Land at Cranesfield, Sherborne St John, Basingstoke

Hampshire County Council Comments Response Technical Note

Document Reference: WIE18375.105.R.4.1.3.TN - Rebuttal

Title
**Proposed Layout
Indicative Pedestrian
Crossing Locations**

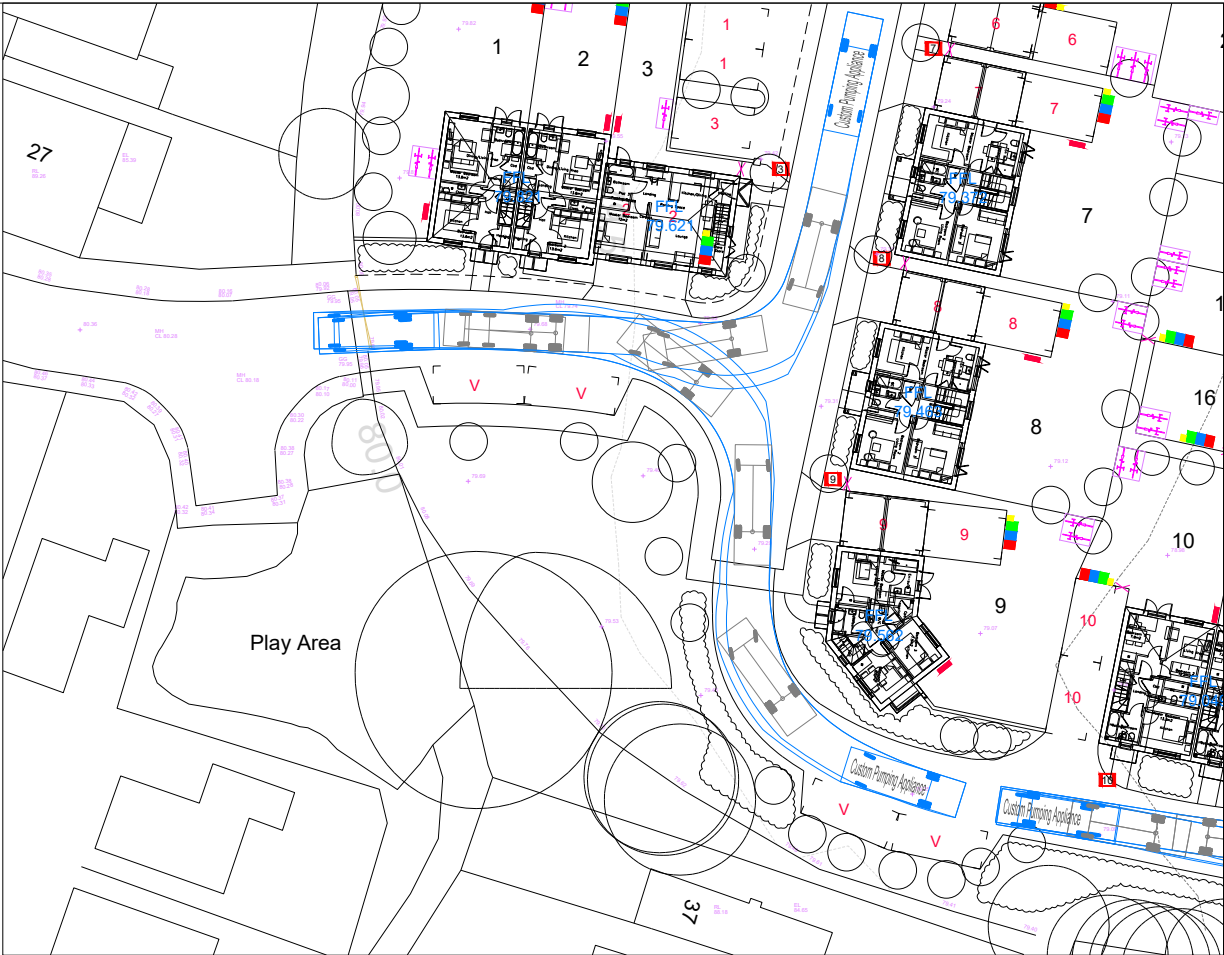
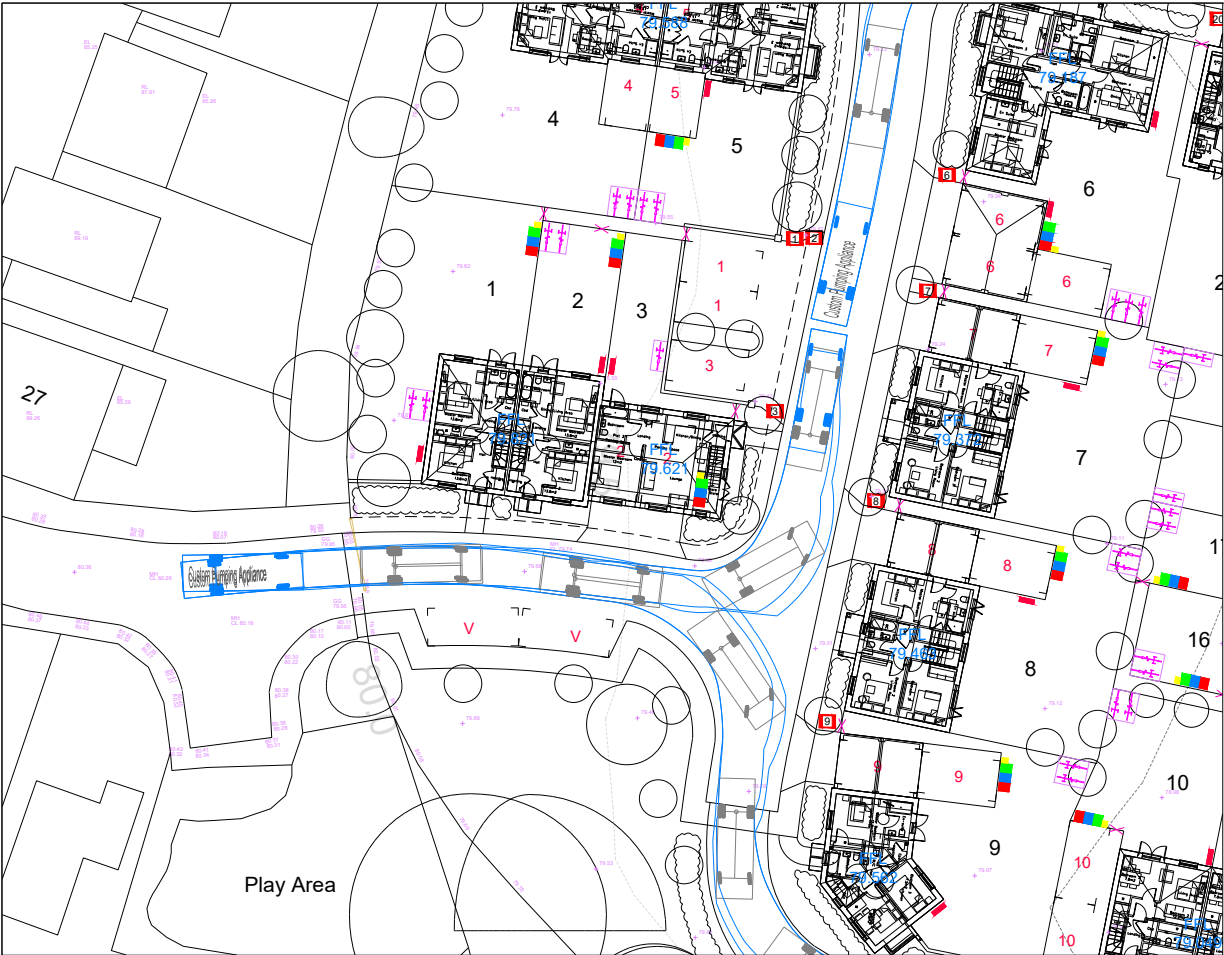
'The location of the uncontrolled crossings based on likely pedestrian desire lines should be shown on a plan.'

- 2.5. Noted, the plan appended to this TN identifies indicative pedestrian crossing locations in keeping with pedestrian desire lines within the site to resolve this comment.

Title
**Proposed Layout
Swept Path Analysis
Emergency/Fire Vehicle**

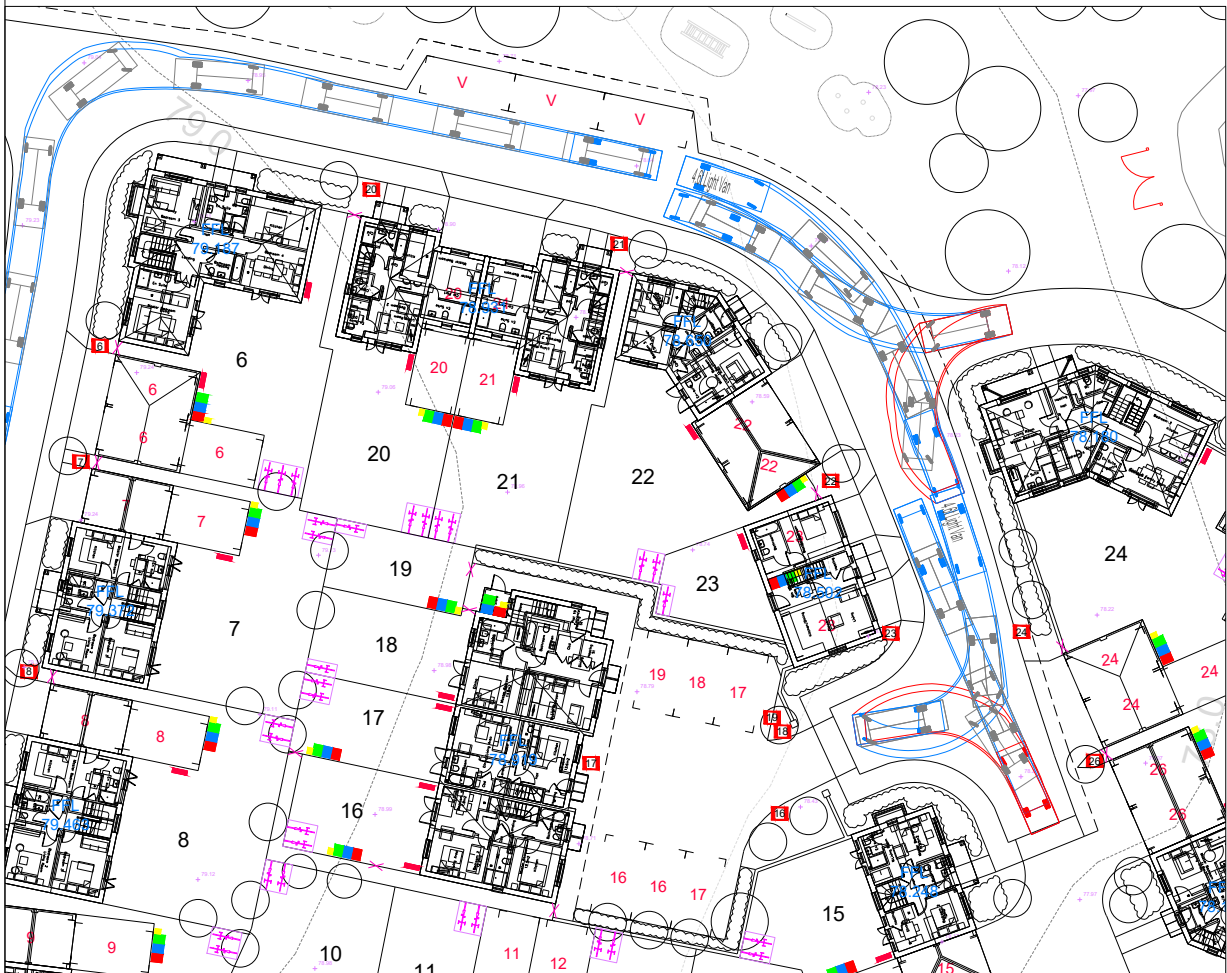
Swept paths should also be provided for a fire tender, and a car & light van.

All vehicle swept paths should be based on a 10mph driven speed, with the vehicle envelopes being contained within the proposed carriageway. Further details on HCC's visibility splay requirements, and the additional swept paths which are required, can be found in TG2 3.2.8.'

- 2.8. Additional swept path has been provided in line with TG2 requirements, appended to this TN (including shared drives). It should be noted that the swept paths, as included within the Transport Statement, demonstrate the worst-case scenario, with all other (smaller) vehicles able to access and navigate the site with relative ease.

Title
**Proposed Layout
Swept Path Analysis
Car Parking - Standard Design Vehicle**

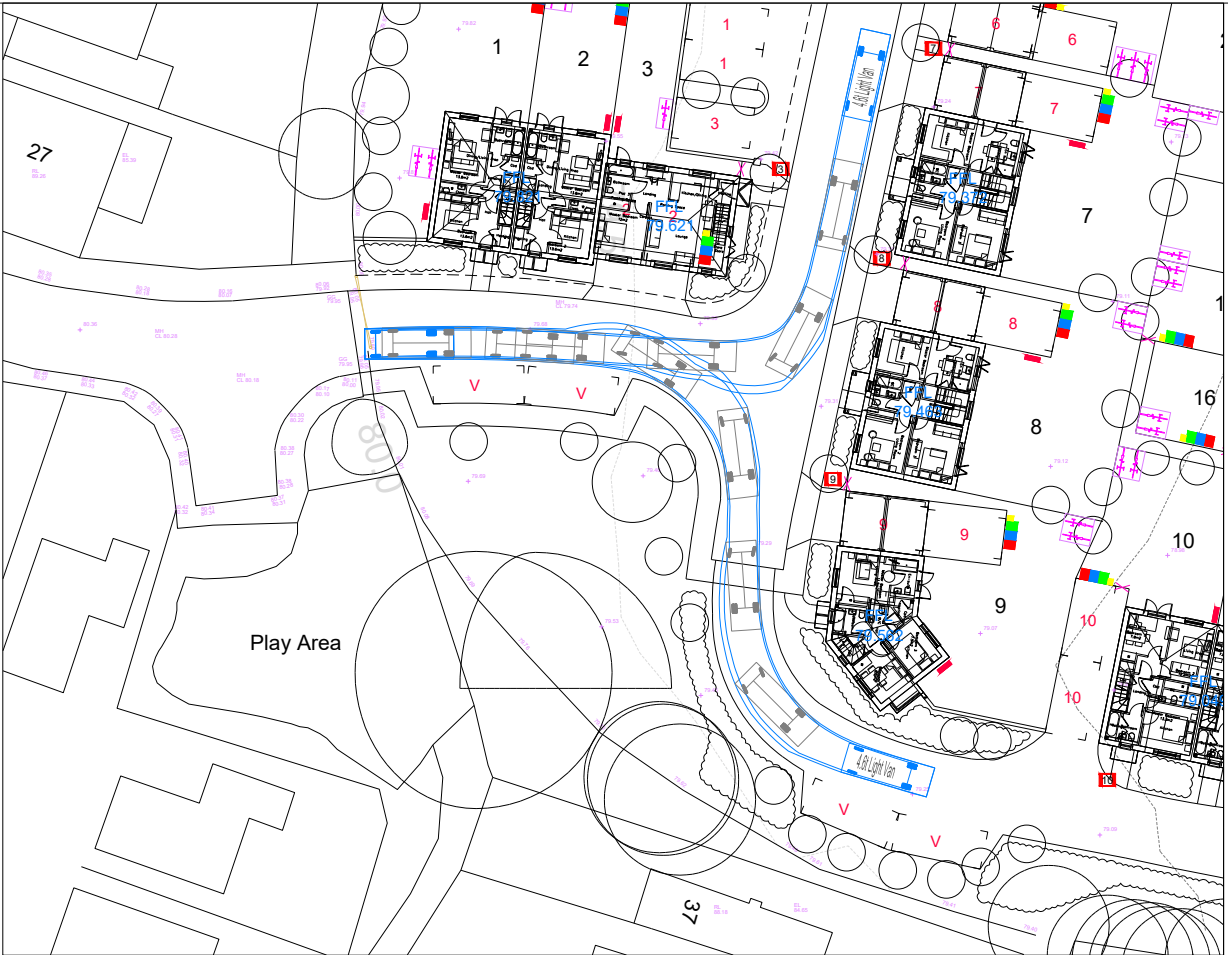
'The refuse vehicle swept path analysis should be undertaken with the design vehicle contained within TG2. It is also requested that large car swept paths are provided for the shared drives. The turning area adjacent to plots 25 and 14 may need to be amended to ensure that vehicles can turn.

- 2.7. The large car (standard design vehicle) swept path already provided as part of the planning submission and appended to the Transport Statement (document ref: WIE18375.103.R.1.1.3.TS) demonstrates swept path for a cross section of the proposed car parking provision, including shared drives.
